DEVELOPMENT PERMIT STAFF COMMITTEE RECOMMENDATIONS

The following is a list of conditions that must also be met prior to issuance of the Development Permit.

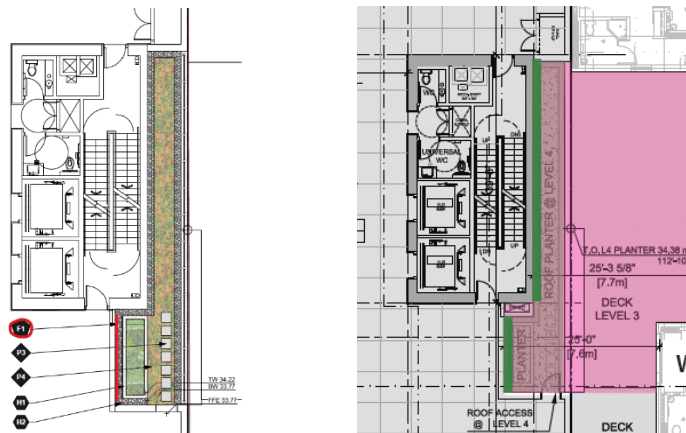
- A.1.14 provision of detail drawings to accurately show typical conditions, including interface between the heritage façade and the contemporary addition, including annotations consistent with work as outlined in the *Conservation Plan*;

- Note to Applicant:** Typical detail drawings should supplement the preliminary wall section drawing 1/A801, confirming that adequate assessment and recording of existing conditions have been conducted to verify scope and feasibility of conservation work proposed.
